Title & Document Type: 8405A Vector Voltmeter Operating and Service Manual

Manual Part Number: 08405-90024

Revision Date: May 1971

VECTOR VOLTMETER 8405A

Figure 7-5. Probe Assembly; (a.) Probe Housing Assy, (b.) Probe Board Assy

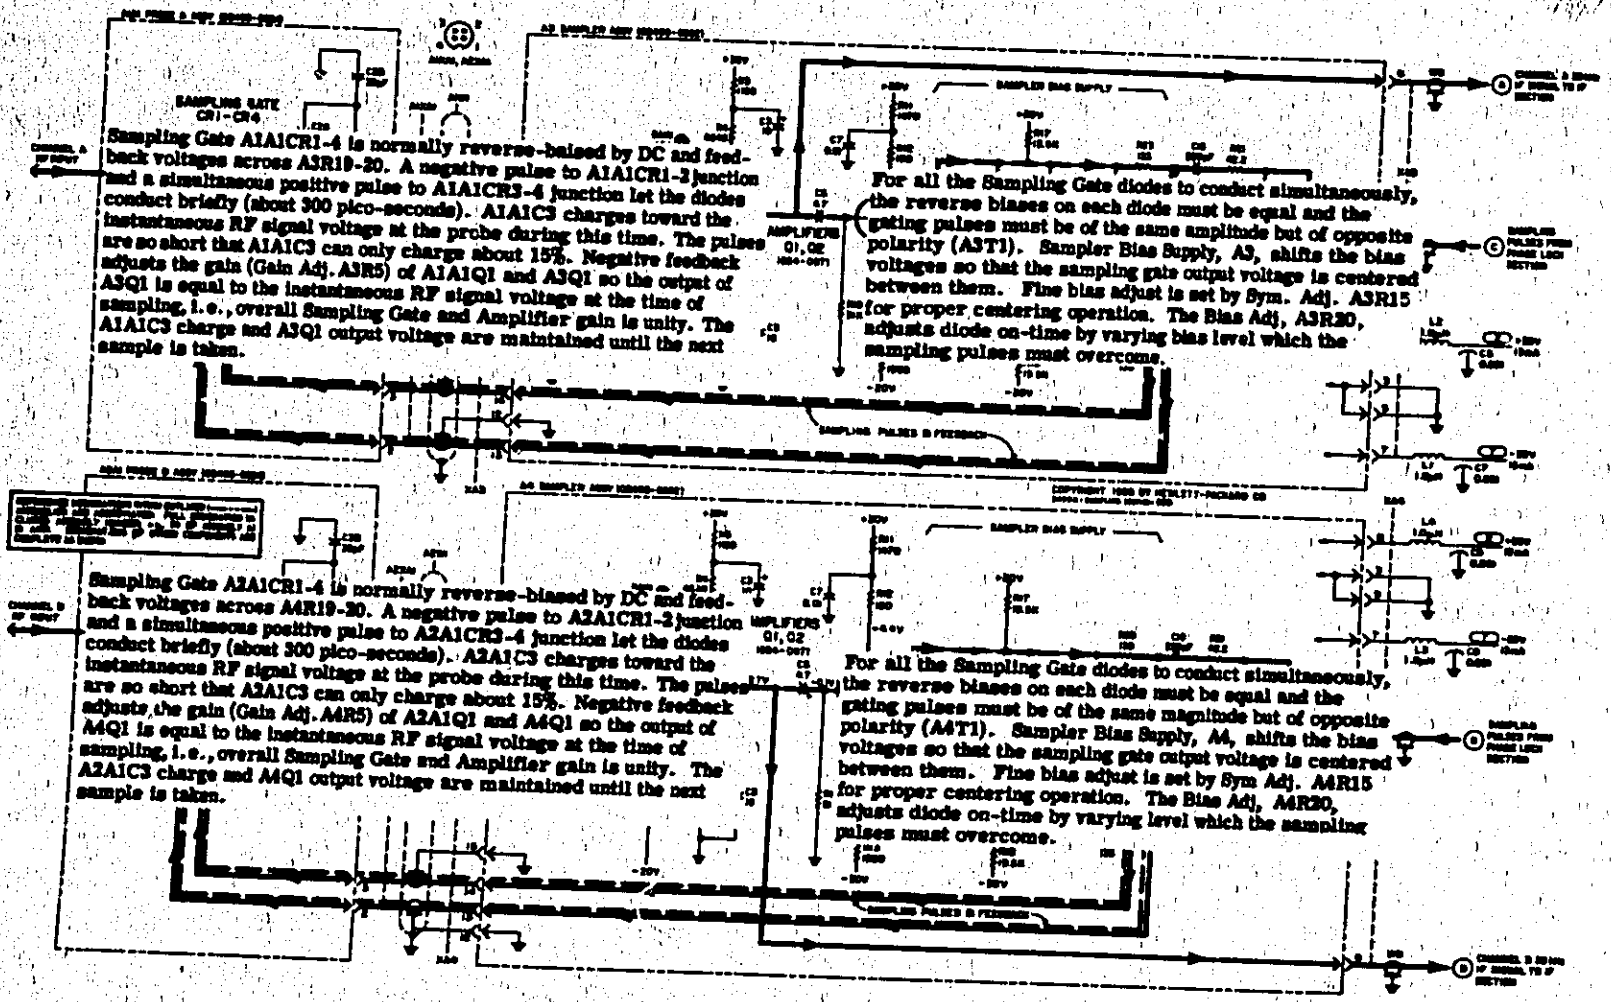
Figure 7-5(b): Change value of A3R21 and A3R26 to 16.7 ohm.

Figure 7-12. Amplitude Range Switch Component Location

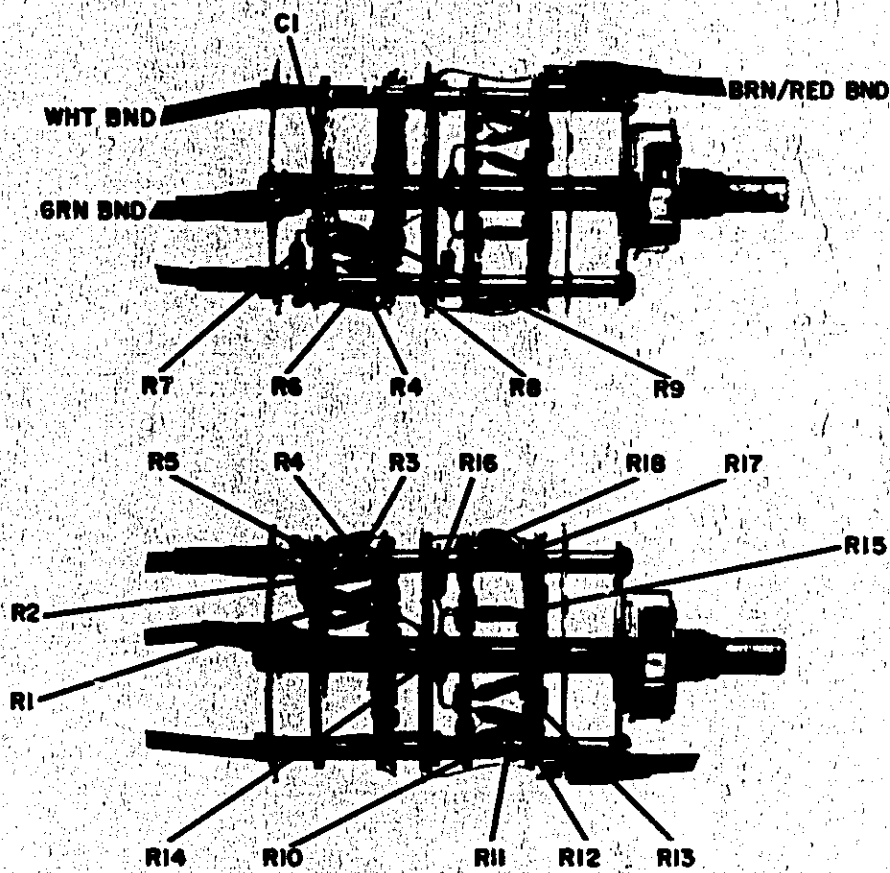
b.) To improve range to range tracking of the VOLTMETER, add capacitor A22C1 to A22 Amplitude Range Switch Assy (see Figures 7-12 and 7-13).

Figure 7-16. Frequency Range Switch Component Location

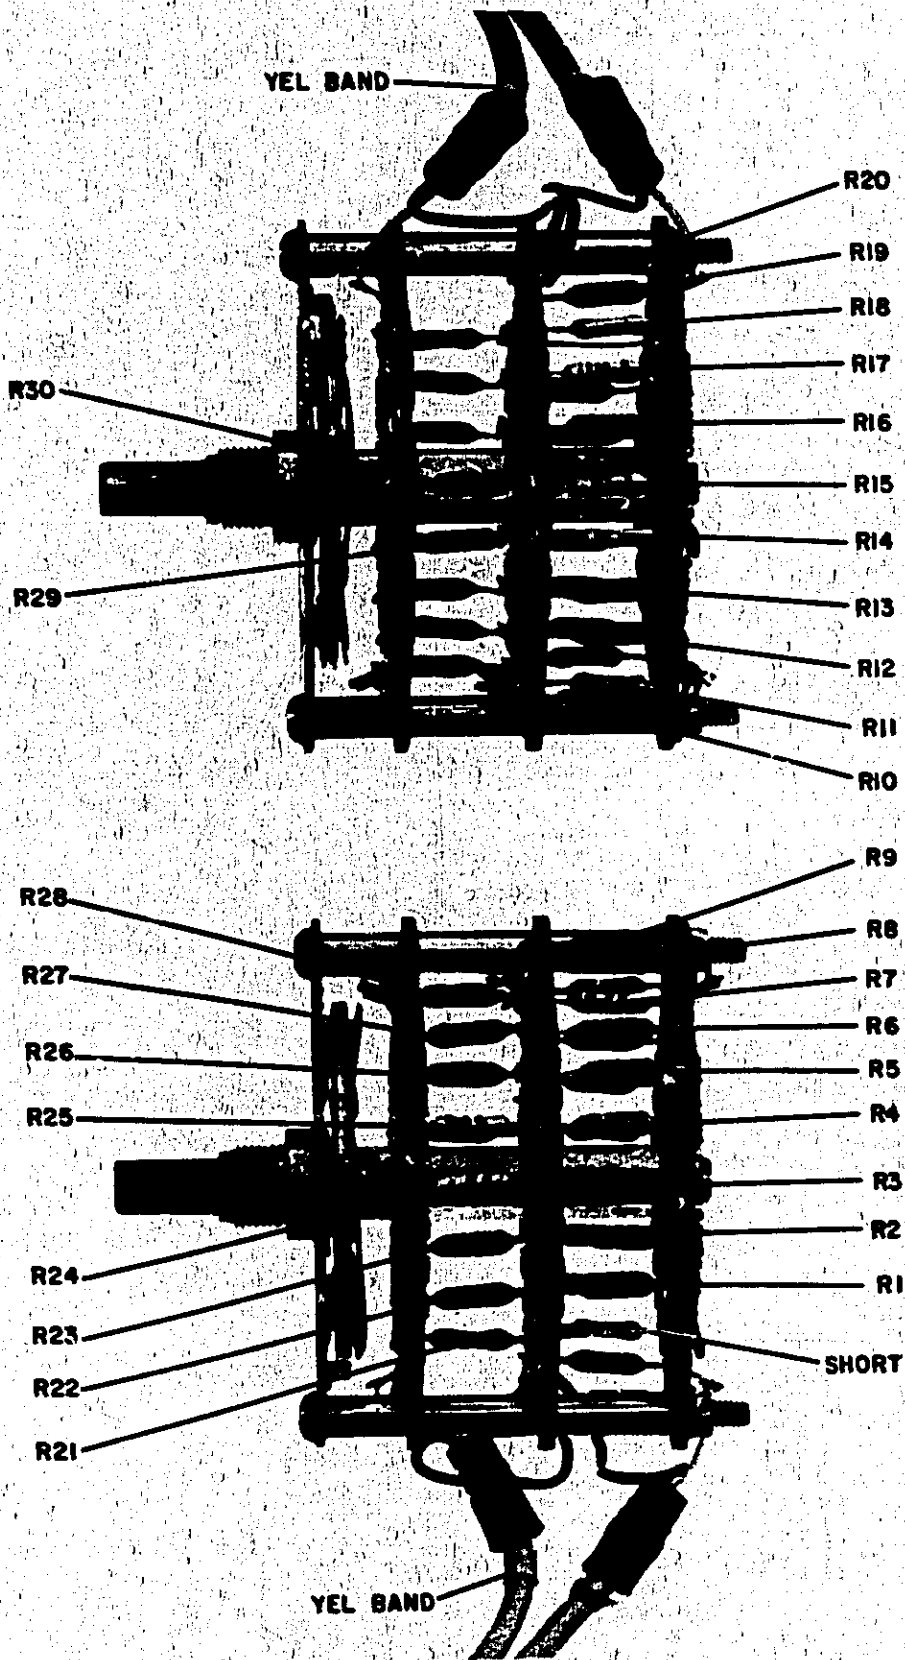
CHANGE 17: To improve performance of the A14 VTO Assy (08405-6014), it is recommended that resistors A14R23 and R4 be added. R4 is to be inserted between pin 9 of XA14 and wiper A of A24 Frequency Range Switch Assy (see Figures 7-16 and 7-17).

Figure 1. Partial Schematic of AB Phase Meter Assy (08405-6008)

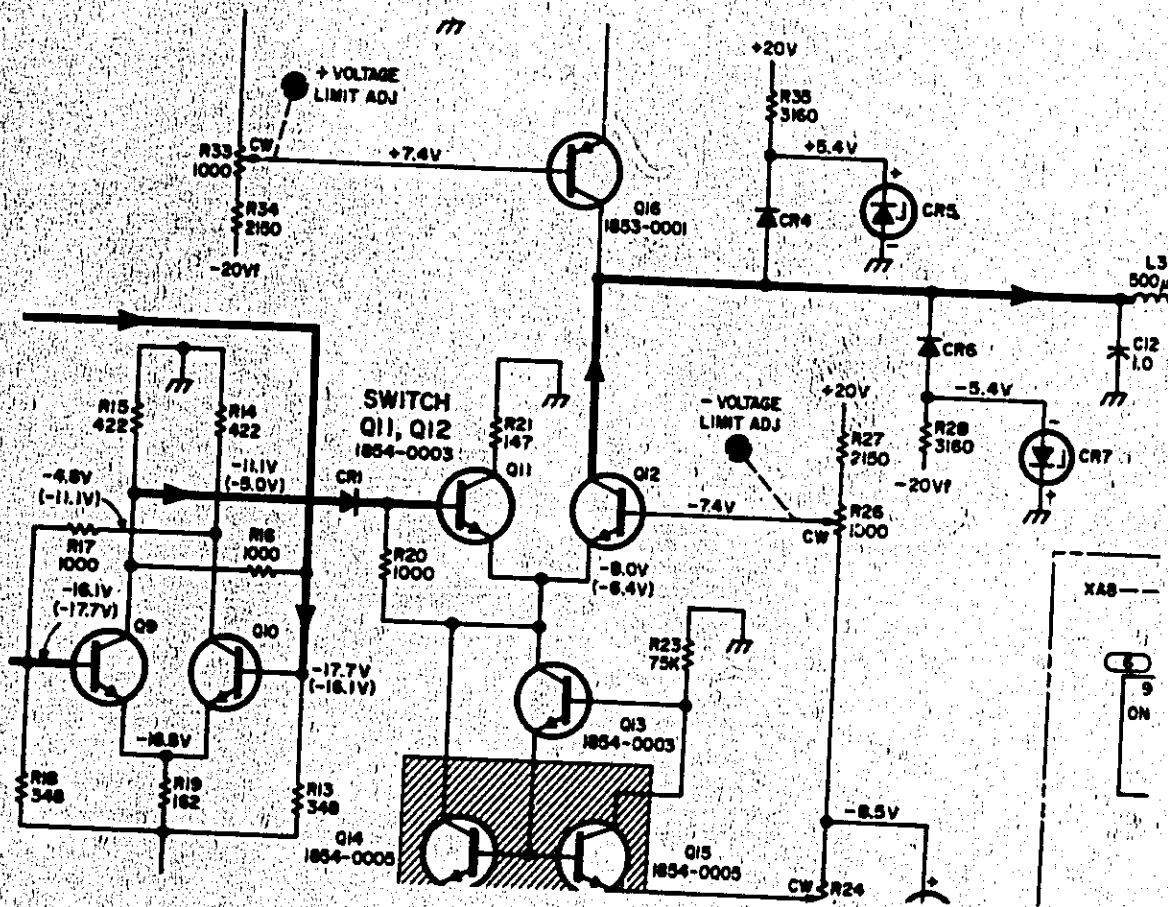
CHANGE 9: AB Phase Meter Assy is different (see Figure 1 below) than shown in Figure 7-11.

Change Resistors ABR27, R34,

To: 0698-0084 R:FXD MET FLM 2.15K OHM 1% 1/8 W
 From: 0698-3101 R:FXD MET FLM 2.87K OHM 1% 1/2 W

Figure 2. Schematic of A11 IF Sampler Assy (08405-6011)

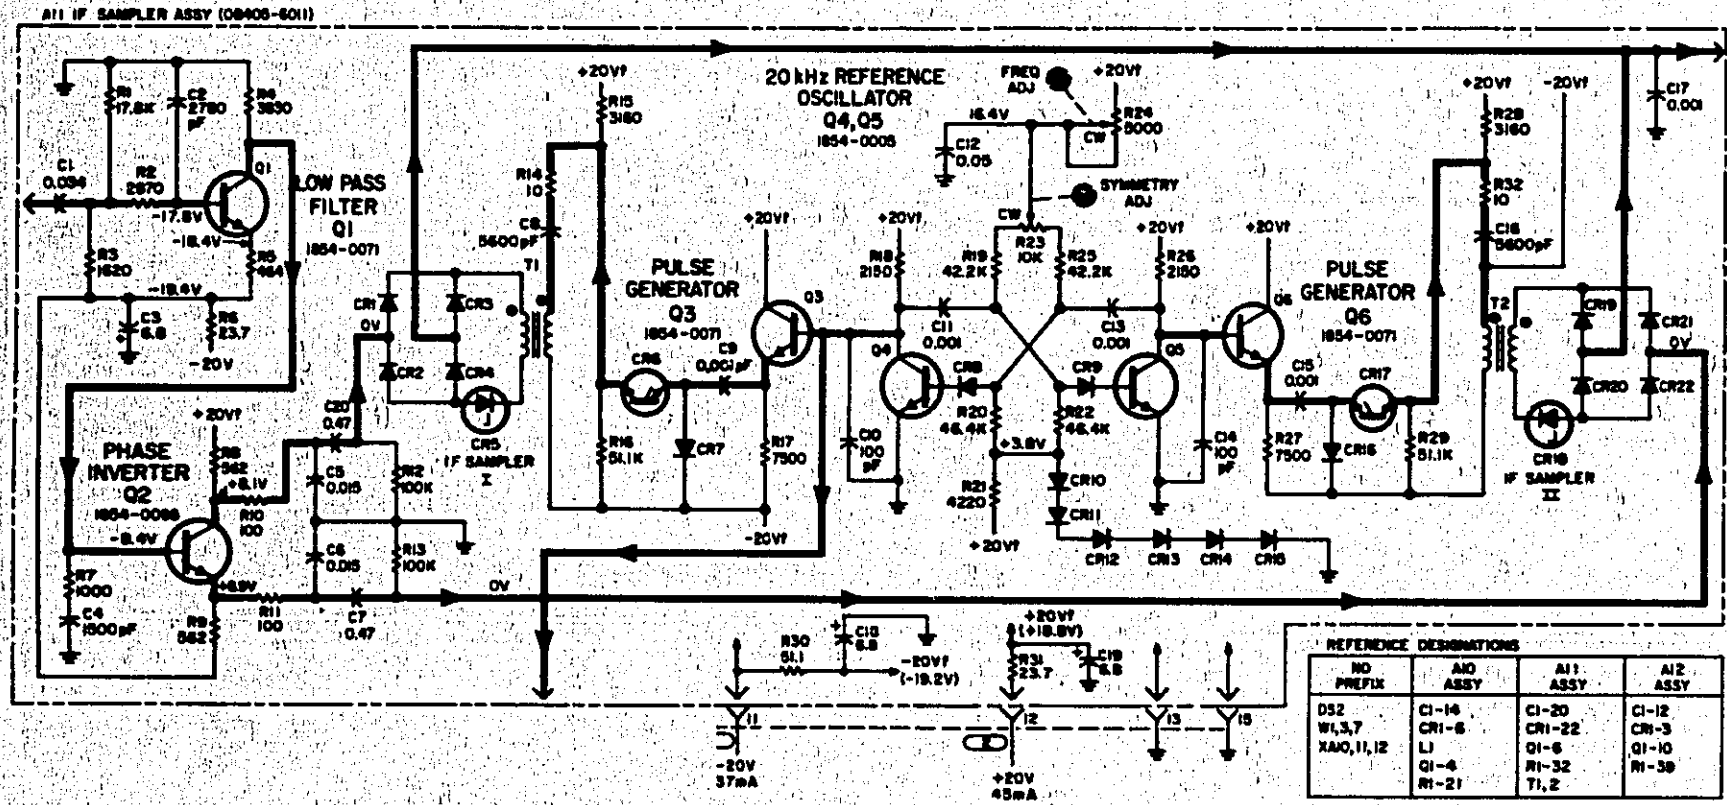
CHANGE 10: a.) All Sampler Assy 08405-6011 is different (see Figure 2) than shown in Figure 7-15.

b.) In the event of A12R27 failure, it is recommended that the value be changed.

From: 0698-3446 R:FXD 383OHM 1% 1/8W
 To: 0686-4315 R:FXD 430Ω 5% 1/2W

Figure 7-18. Power supplies (Partial Schematic) (CHANGE 7)

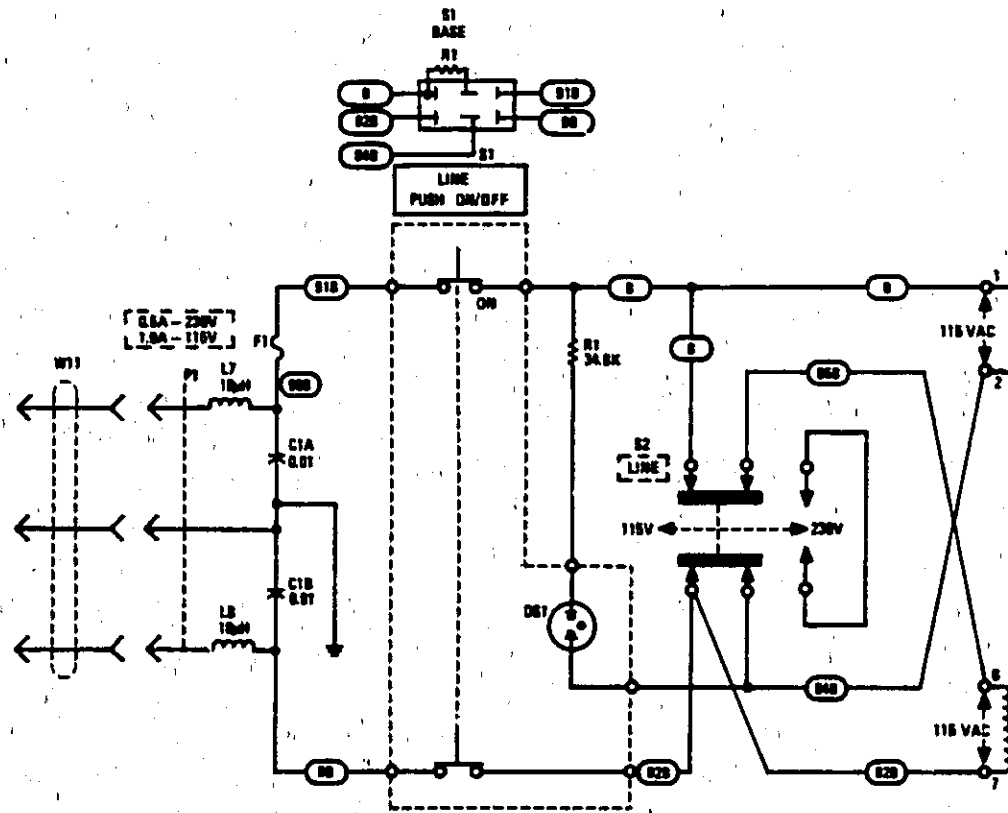
Figures 7-18(a) and 7-18(b):
Change primary power circuit per Figure 7-18 in this change sheet (CHANGE 7).

P/O Figure 7-15(b). Schematic Diagram, Automatic Phase Section (Part 1) (CHANGE 11)

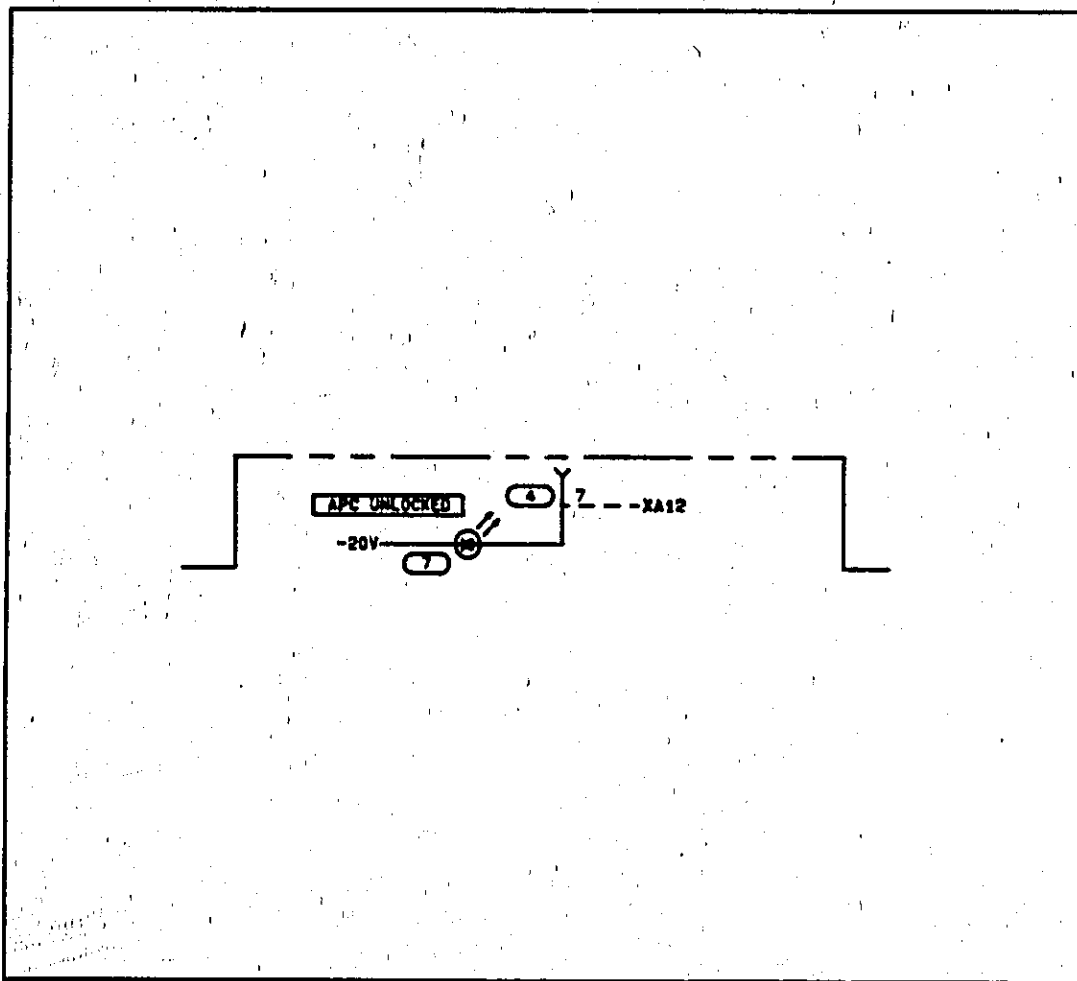
Change the A12DS2 symbol using the partial schematic in this document [P/O Figure 7-15(b) (CHANGE 11)].
